Menlo-Atherton High School Campus Facilities Master Plan

FINAL PROGRAM ENVIRONMENTAL IMPACT REPORT

July 9, 2015

SEQUOIA UNION HIGH SCHOOL DISTRICT
480 JAMES AVENUE
REDWOOD CITY, CA 94062

Photo 33: View from 212 Oak Grove Avenue, looking south / south east (D/E balloon trial is visible). The large oak tree in the center of the photograph could be removed as part of the FMP.

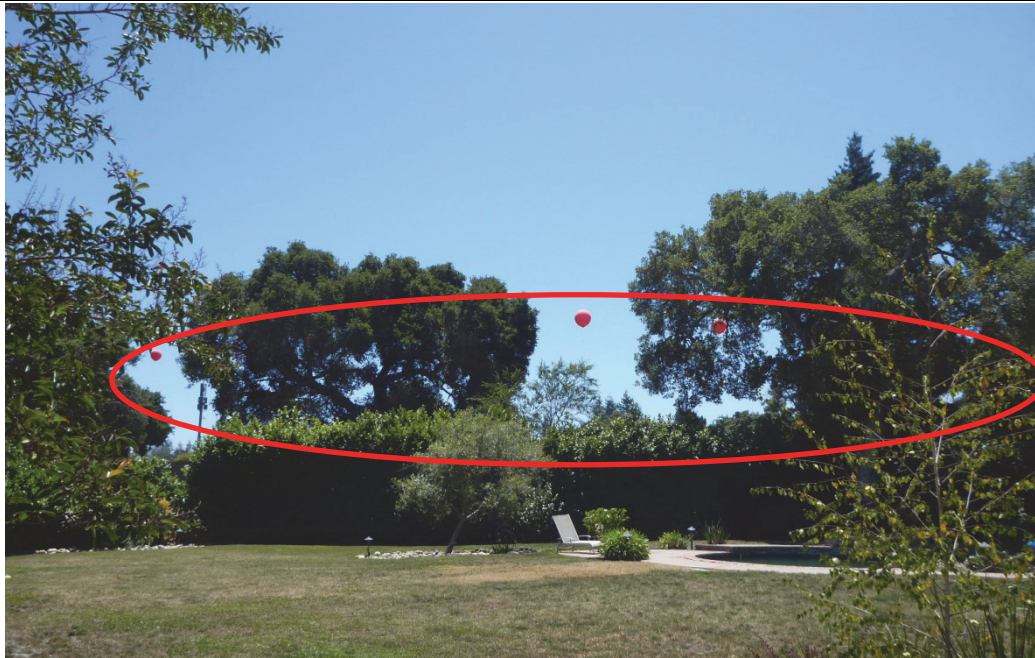
On page 5-19, the following photographs are added to Figure 5-2, Photographs of MAHS and Surroundings (see proceeding page):

Supplemental pictures and text describing the evaluation have been added to the discussion under Impact AES-1 in Section 5.3.2 of the EIR. The supplemental pictures confirm that the new G-Wing and future replacement D/E Classroom Building would be noticeable to residents on Oak Grove Avenue, but would not change the findings of the Draft Program EIR (i.e. Impact AES-1 would be less than significant with mitigation measures AES-1A to AES-1E).
